## Part B – Please use a separate sheet for each representation

Wisloe Action Group

3. To which part of the Local Plan does this representation relate?

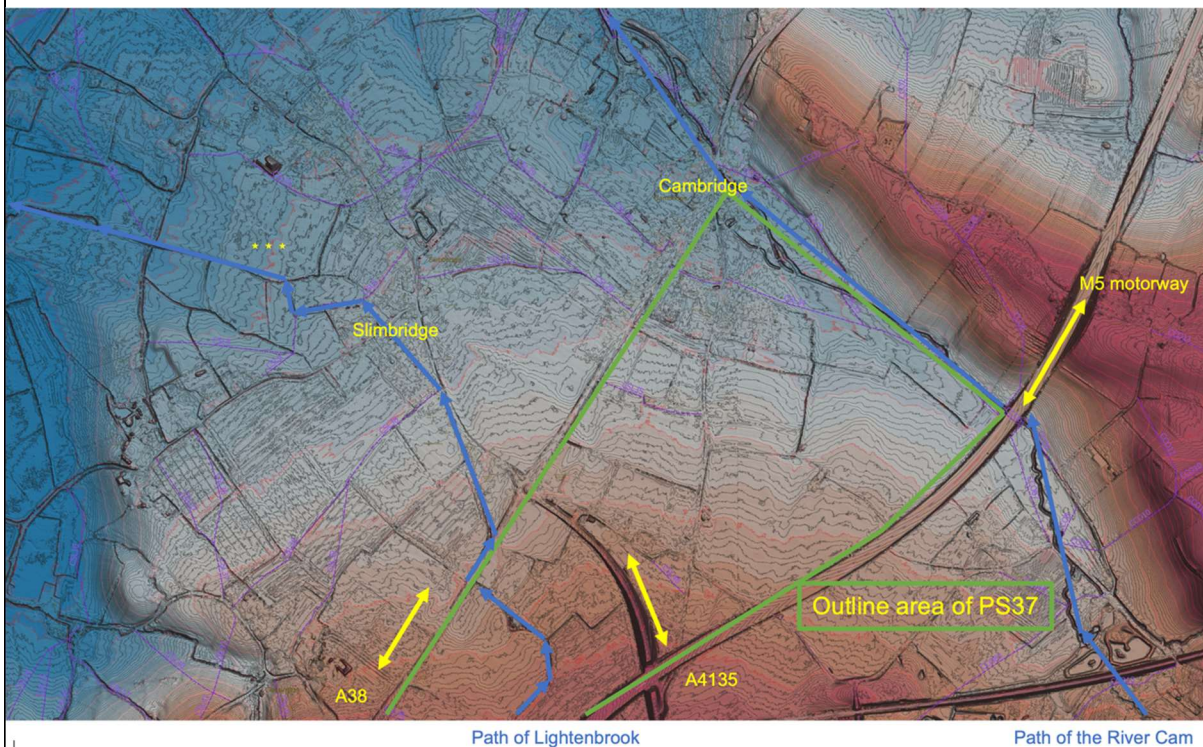
2. In fully understanding the topography it is important to understand that all the existing villages and settlements are downhill and therefore downstream from PS37 Wisloe. Therefore, water runs from the M5 and beyond to the west, across the development. There are two critical paths for surface water, the River Cam and Lighenbrook. The River Cam forms the northerly boundary to the portion north of the A4135. Lighenbrook (or Lighen Brook) emanates from another site included in the Local Plan, PS24 West of Draycott, on the far side of the M5, and goes on to bisect the southerly portion. The A4135 forms an impenetrable raised barrier between the two portions of the proposed development and therefore, for flooding, and indeed, other purposes, the two portions should be addressed individually.

3. This is graphically illustrated on this diagram which uses Environment Agency (EA) lidar contour data. Red areas are high ground, blue areas low.

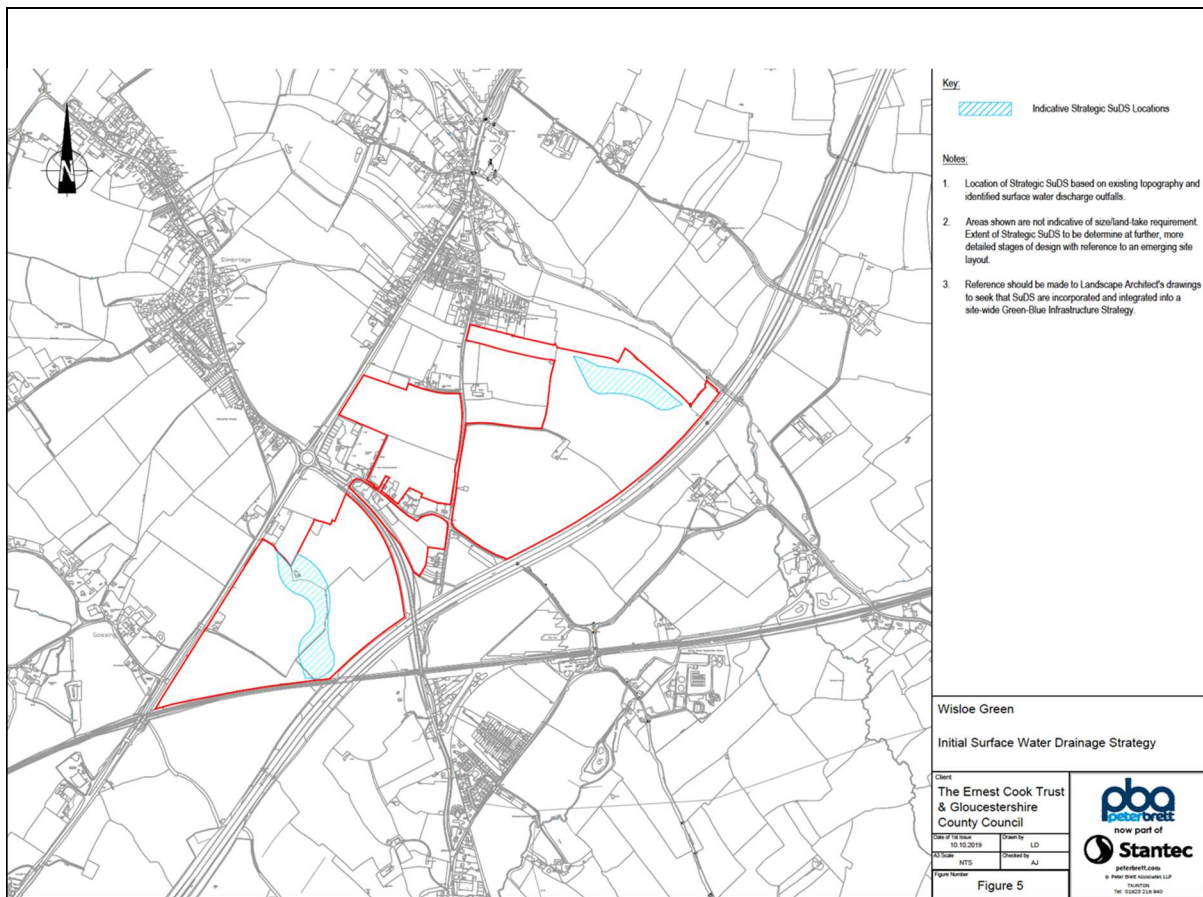
37. GCC LLFA says it is aware of a known downstream flood risk and that discharge rates should preferably be limited to existing present-day rates up to the 1:100-year event. This is incorrect. It is not preferable, nor should it be reference to the 1:100-year event rate. Flooding is already being experienced from the site at the 1:1,000-year event rate. Reference 3 states that 'Developers must seek opportunities to reduce overall level of flood risk both on and off-site, for example by reducing volume and rate of runoff and creating space for flooding'. See also NPPF para 155 given earlier which makes protection of surrounding settlements mandatory.

38. The Stantec report suggests this can be achieved by constructing two vast storage attenuation areas, one in each section of the development. It calculates the need to accommodate between 771 and 967m<sup>3</sup> of attenuation storage per hectare of impermeable development. As the report states, the whole 82 hectares of the site is underlain with a bedrock of Blue Lia Formation and Charmouth Mudstone Formation Mudstone and therefore all of it is considered impermeable. This then equates to a requirement for between 63,222 and 79,294m<sup>3</sup> of attenuation storage. The map below shows the likely extent of the required storage. While Note 2 states that the areas are not indicative of size/land-take requirements. Earlier incomplete information on the nature of Lightenbrook suggests that the area shown is an underestimation. This is further explained later.

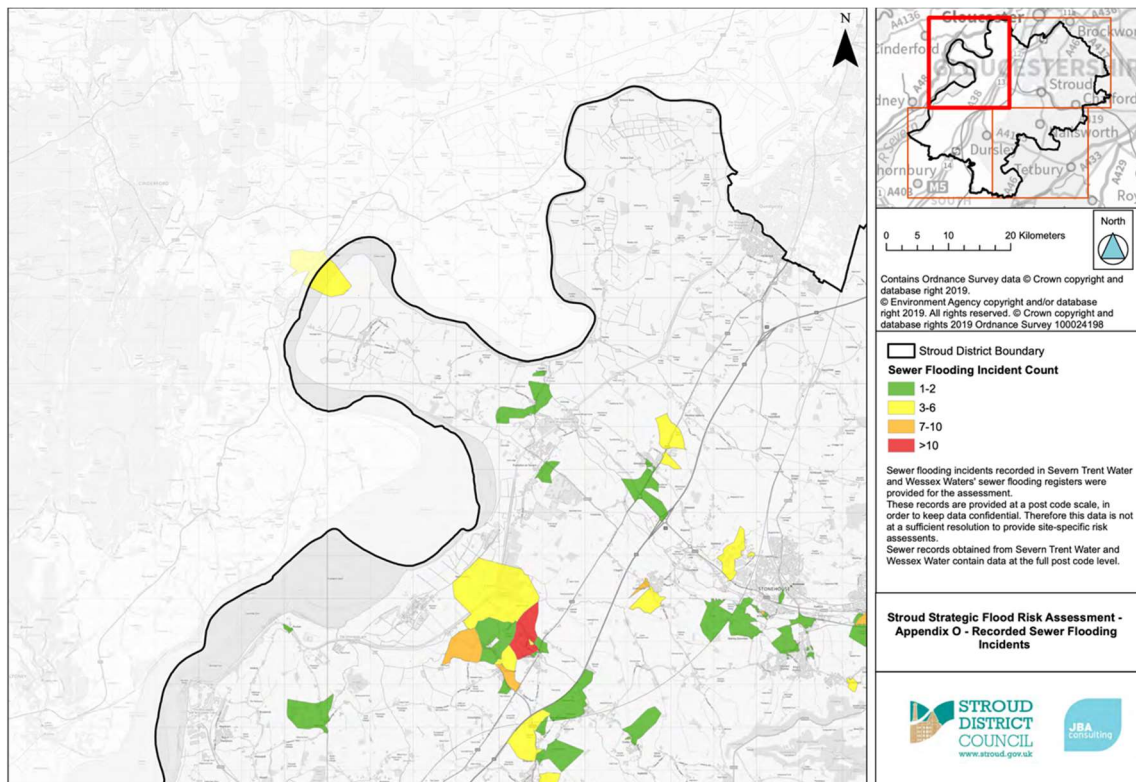
51. Appendix M to the SFRA highlights the risk of groundwater flooding ( $\geq 75\%$ ) in the southerly section (Lightenbrook) of the site.

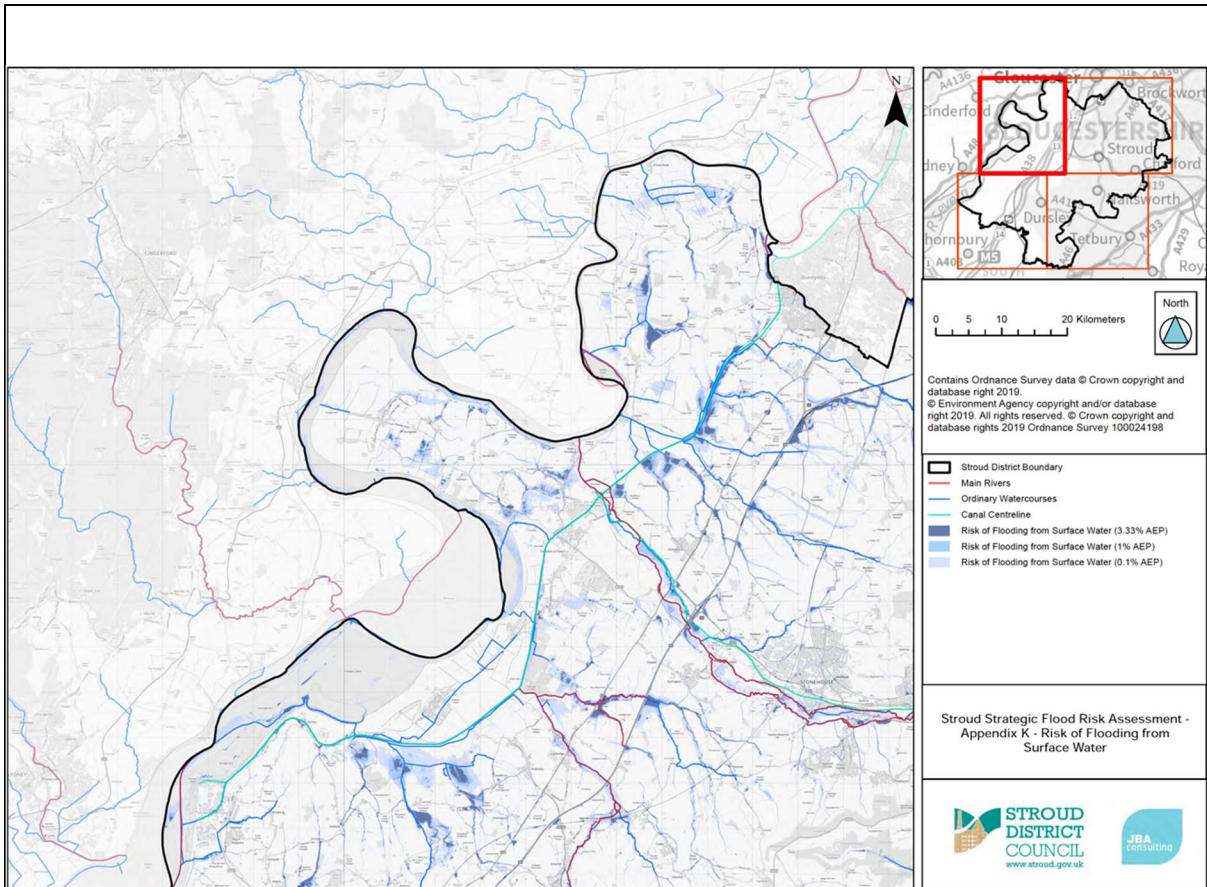
60. The SFRA<sup>8</sup> data used by the proposers in making their calculations in 2019 is shown on the map below. The conditions experienced and witnessed by residents in December 2020 exactly match the light blue, 0.1 AEP area on the map. As stated in the GCC report, that AEP is now 20% not 0.1%. Therefore, it is 200 times more likely to be experienced. Now it is once every 5 years, not once every 1,000 years. As I write this, guess what? The cataclysmic flooding in Germany, Belgium and the Netherlands was forecast on a 1:1,000-year basis! Not any more!

Flooding from PS37 23 December 2020

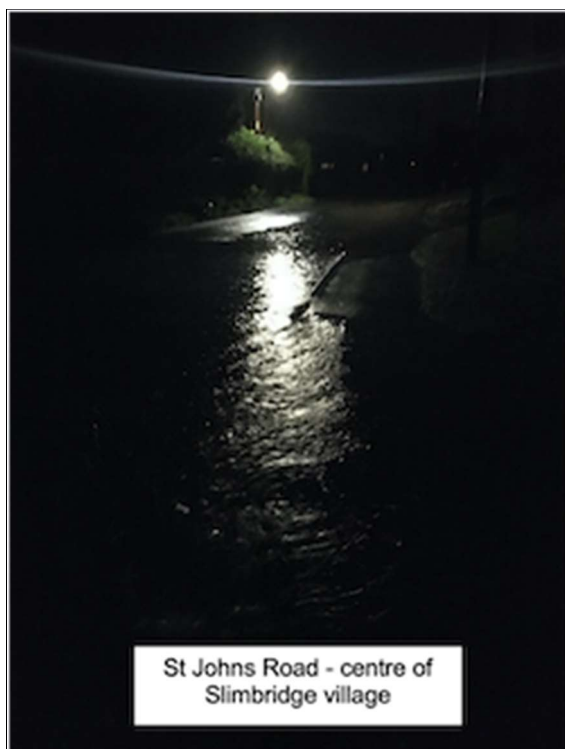
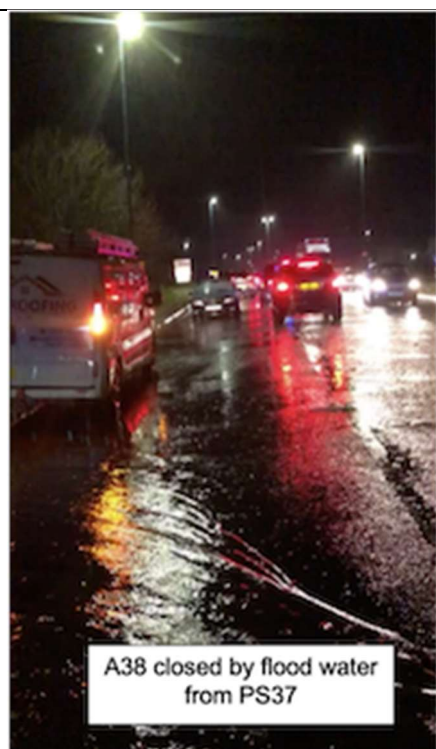
A38 closed by flood water from PS37

Fields around the village still flooded days later. The church can be seen in the distance
